**SHINE TECHNOLOGIES, LLC APPLICATION FOR AN
OPERATING LICENSE SUPPLEMENT NO. 23**

**FINAL SAFETY ANALYSIS REPORT CHANGE SUMMARY
PUBLIC VERSION**

Summary Description of Changes	FSAR Impacts
Update to reflect changes to the valve and damper position feedback to the target solution vessel (TSV) reactivity protection system (TRPS) and engineered safety features actuation system (ESFAS) following safety actuation and to clarify the description of the reliability of the process integrated control system (PICS).	Figure 7.4-1, Figure 7.5-1, Section 7.6
Update to correct required isolations of radiological ventilation systems in response to a tritium release.	Section 7.5, Figure 7.5-1, Section 13a2.2
Update to correct the instrument accuracy associated with the wide range neutron flux, correct the response time associated with the molybdenum extraction and purification system (MEPS) heating loop radiation instrumentation, and provide clarification to coincidence logic.	Table 7.4-1, Table 7.5-1
Update to correct errors in TRPS and ESFAS logic diagrams.	Figure 7.4-1, Figure 7.5-1

Figure 7.3-1 – Process Integrated Control System Architecture

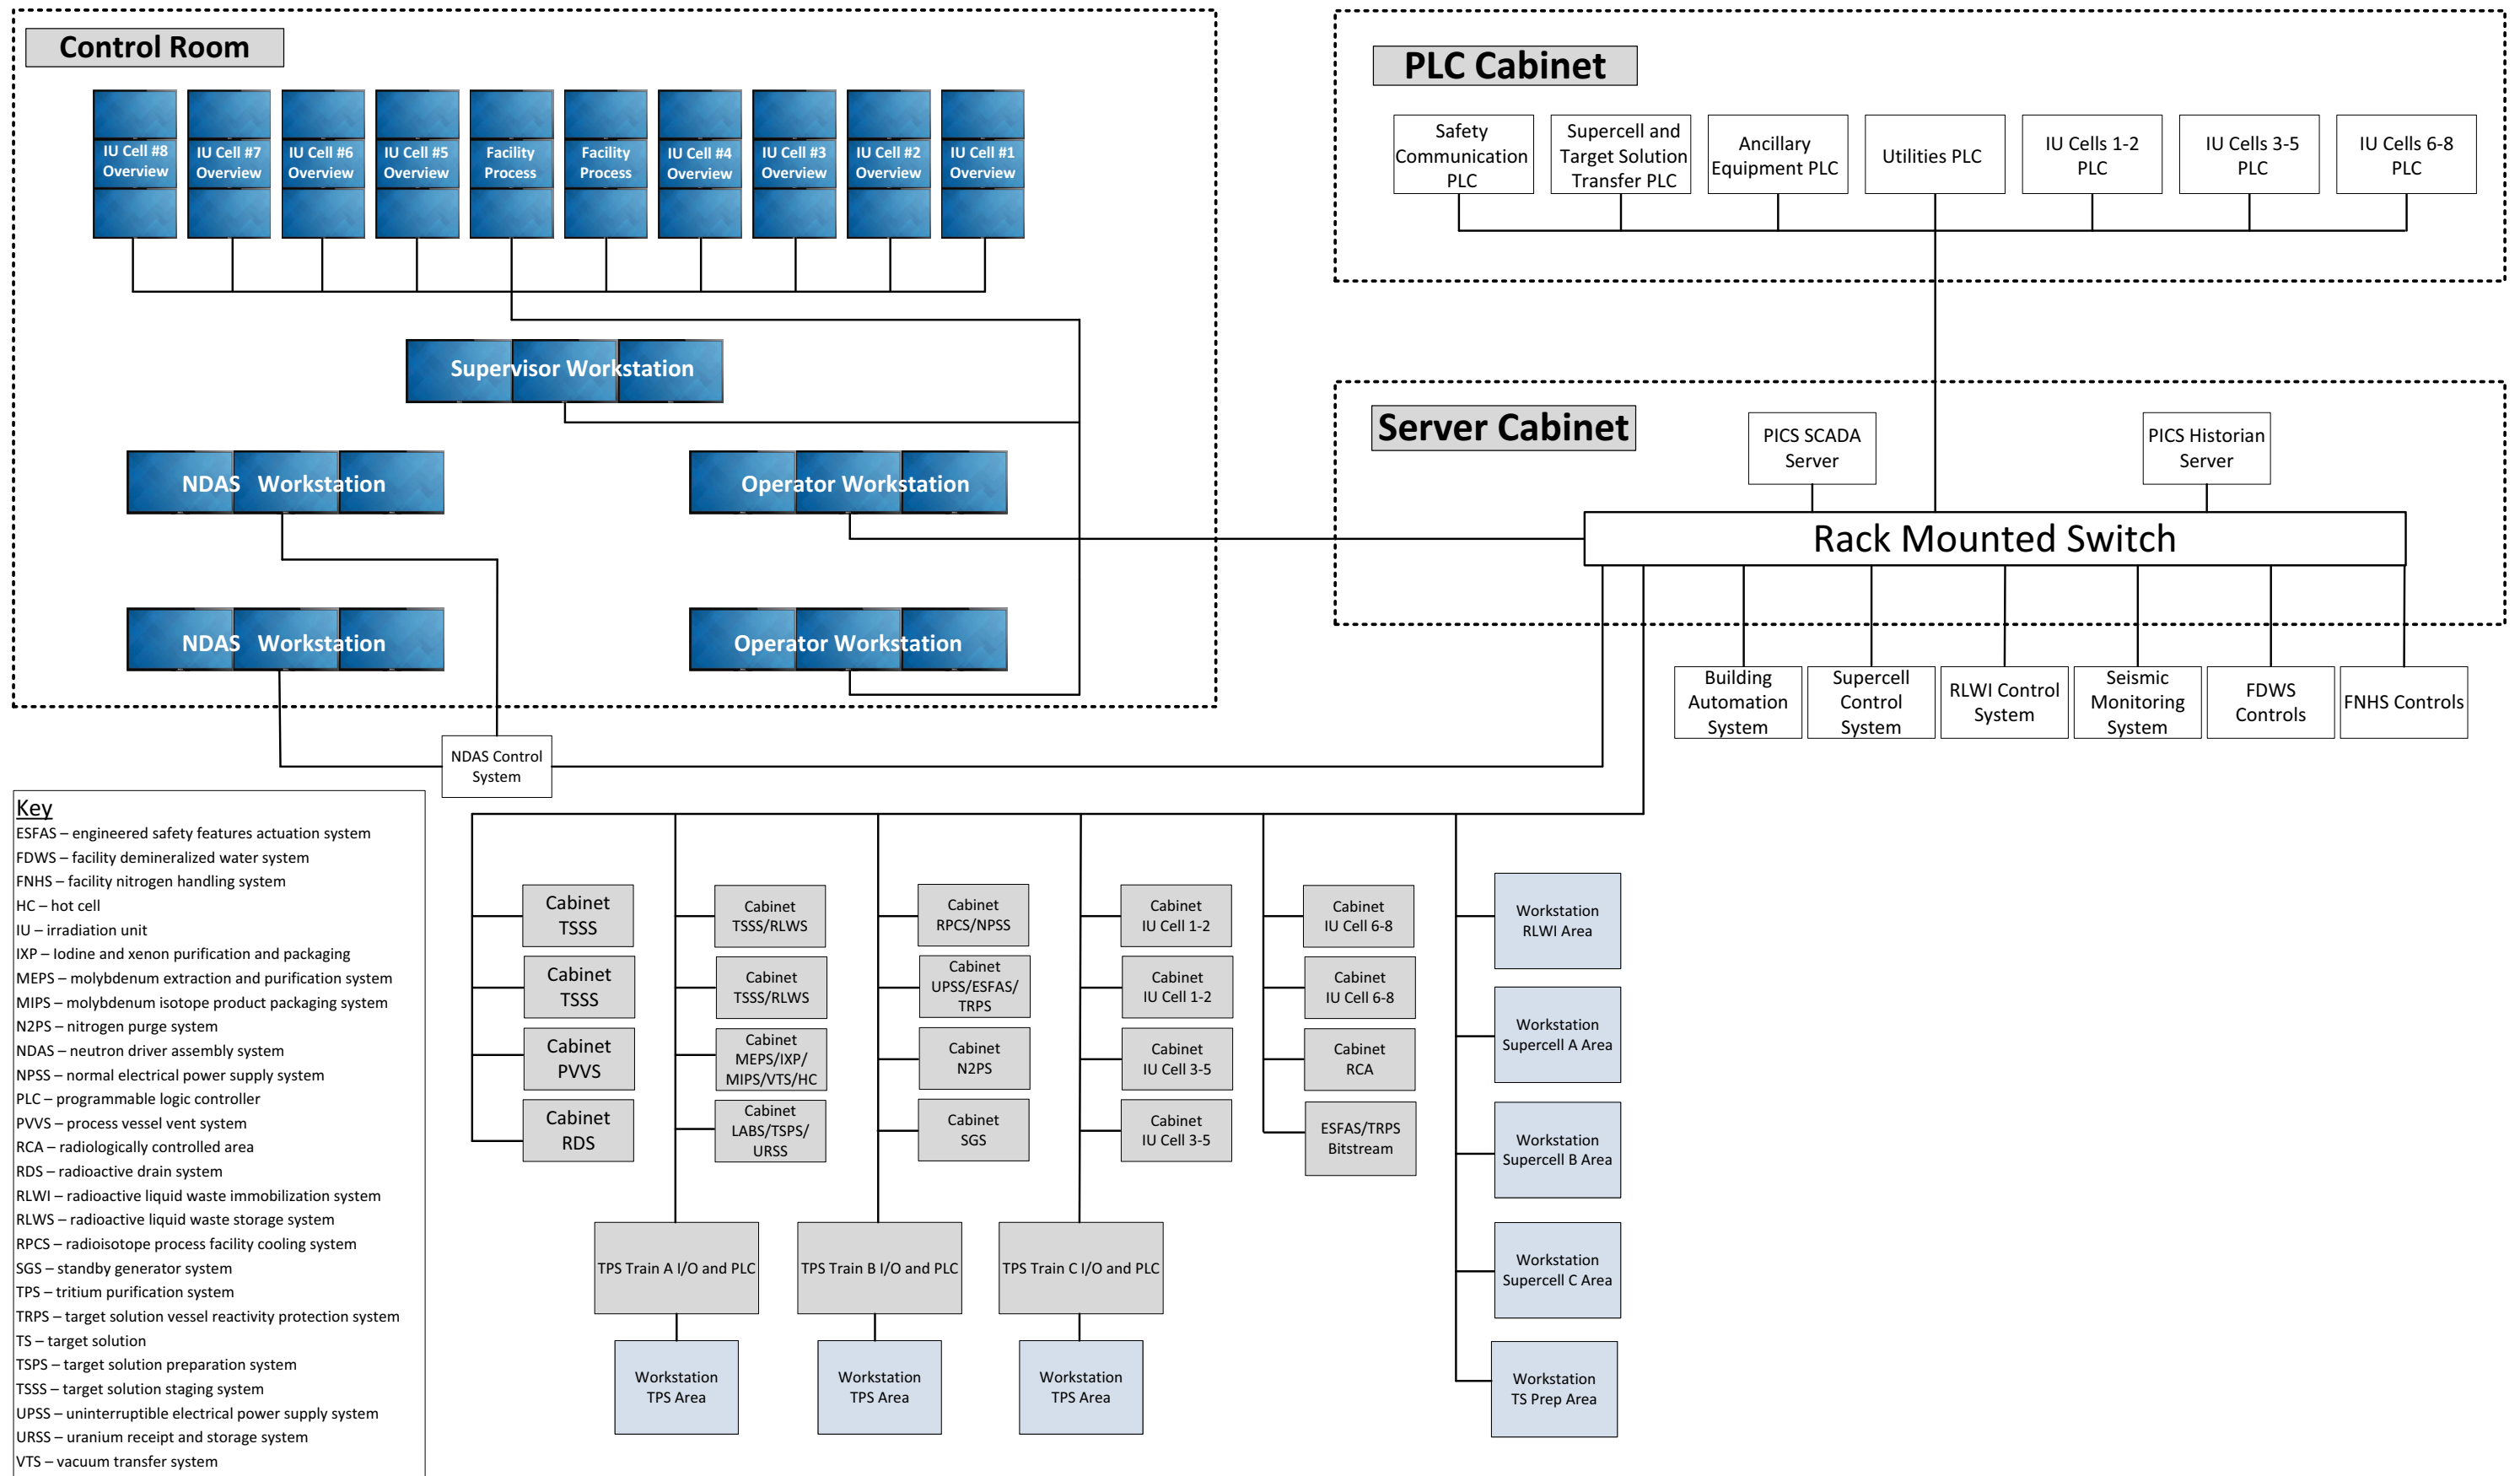
Update to reflect design progression of PICS architecture.	Figure 7.3-1
Update to clarify the control functions that PICS provides in relation to TRPS and ESFAS.	Section 7.3
Update to correct references to the Tritium Purification System (TPS) Process Vent Actuation and to clarify the safety functions initiated by a MEPS A/B/C Heating Loop Isolation.	Section 7.5, Figure 7.5-1

~~The PICS provides signals to the TRPS and ESFAS to provide normal control of~~ Safety-related components that are capable of being actuated by the TRPS or ESFAS. G, but also have a nonsafety-related function related to production, achieve their safe state by having power removed. PICS controls these components directly by cycling power through the use of relays and contacts and does not send a signal to the TRPS or ESFAS during these normal operations. Should a safety actuation be required, the TRPS or ESFAS opens a contact in series with the power supply to the component, causing it to achieve its safe state regardless of the control signals from the PICS are only accepted by. Following the safety actuation, the PICS provides a nonsafety-related control signal to the TRPS and/or ESFAS when to allow for component repositioning. The actuation and priority logic (APL) in the TRPS or ESFAS processes these signals based upon the position of the associated enable nonsafety switch located on the main control board is in the “enable” position. Details of the control signals provided by PICS are described in [Subsections 7.4.3.4](#) and [7.5.3.3](#).

Safety-related components that are capable of being actuated by the TRPS or ESFAS and do not have a nonsafety-related production function are not controlled directly by PICS. Following the safety actuation, the PICS sends a nonsafety-related control signal to the TRPS or ESFAS and the APL in the TRPS or ESFAS processes this signal based upon the position of the enable nonsafety switch. If not prevented by higher priority inputs to the APL, the TRPS or ESFAS will position the component as requested by the PICS.
